### Charlotte-Mecklenburg Planning, Design, & Development

**SUBJECT:** Administrative Approval for Petition No. 2018-028 & 2001-030

Attached is the revised site plan for the petition above. This request allows the modification of the proposed site plan as listed below. Since these changes do not alter the intent of the development and meets the requirements of the Charlotte Zoning Ordinance Section 6.207 <a href="Alterations to Approval">Alterations to Approval</a>, minor changes, I am administratively approving this plan. Please use these plans when evaluating requests for building permits and certificates of occupancy.

RZ-

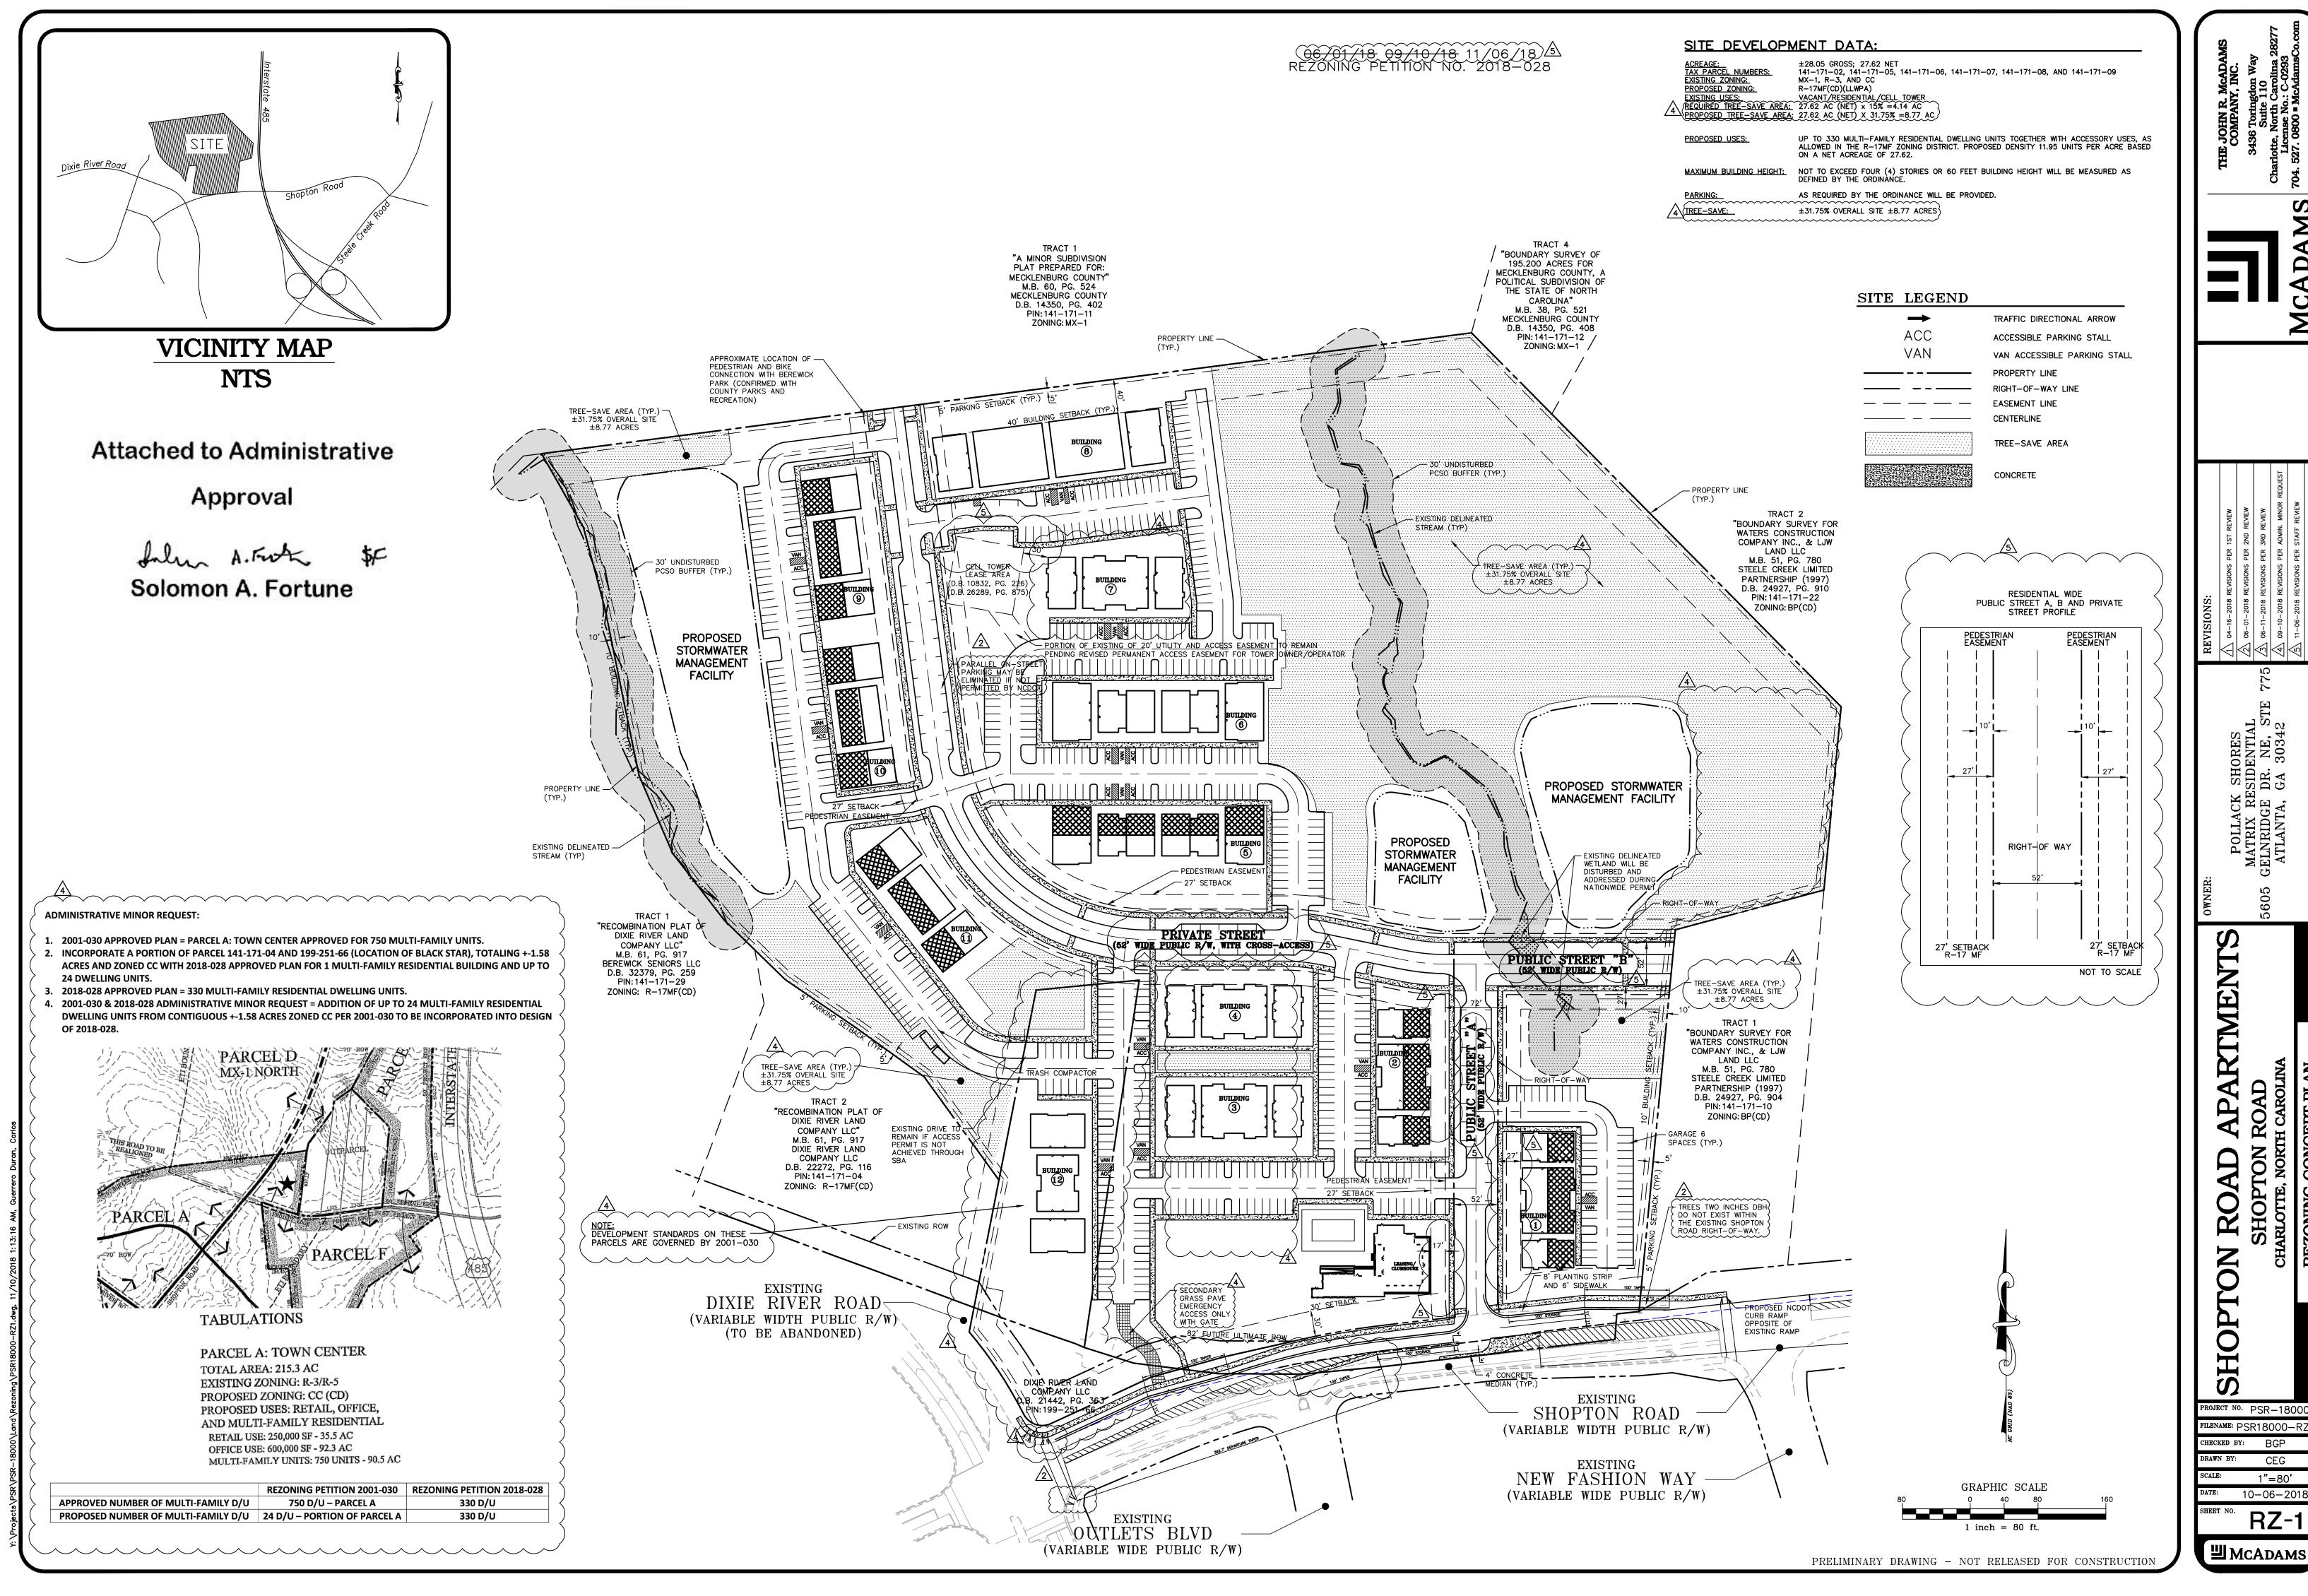
- o Portion of development area approved under Petition 2001-030 included with area approved for Petition 2018-028.
- Site Layout
- Conditional notes

Staff supports of the request because:

• The site plan complies with the conditional notes and still meets the intent of the original approval by the City Council.
